PIC32MZ EF FAMILY

PIC32MZ Embedded Connectivity with Floating Point Unit (EF) Family Silicon Errata and Data Sheet Clarification

FIGURE 1: POSC CRYSTAL CIRCUIT

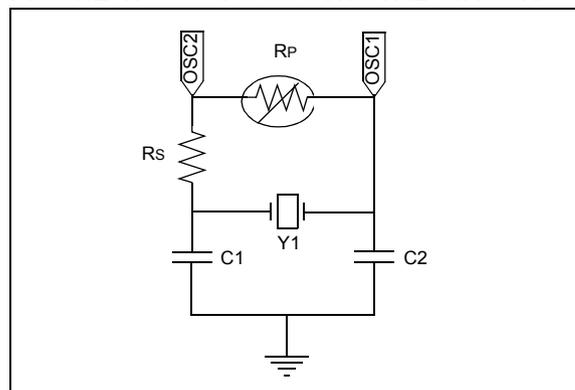
Revision A1 Silicon: A crystal oscillator cannot be used as an input to the Primary Oscillator (Posc) pins OSC1 and OSC2.

Revision A3 Silicon: The Posc has been tested in a normal power-up sequence and supports specific crystal operation.

The Primary Oscillator (Posc) has been characterized to operate at 8 MHz, 12 MHz, and 24 MHz when the circuit in [Figure 1](#) is implemented, and the operating conditions listed in [Table 3](#) are met.

Crystal Frequency (see Note 1)	Series Resistor (Rs)	Posc Gain Setting POSCGAIN<1:0> (DEVCFG0<20:19>)	Posc Boost Setting POSCBOOST (DEVCFG0<21>)
8 MHz	2 kΩ	'0b00 (GAIN_0)	'0b1 (ON)
12 MHz	1 kΩ	'0b00 (GAIN_0)	'0b1 (ON)
24 MHz	0 kΩ	'0b00 (GAIN_0)	'0b1 (ON)

- Note 1:** Using any other crystal frequency will require special component selection and characterization.
Note 2: A parallel resistor (Rp) should not be used to increase the gain of the POSC.
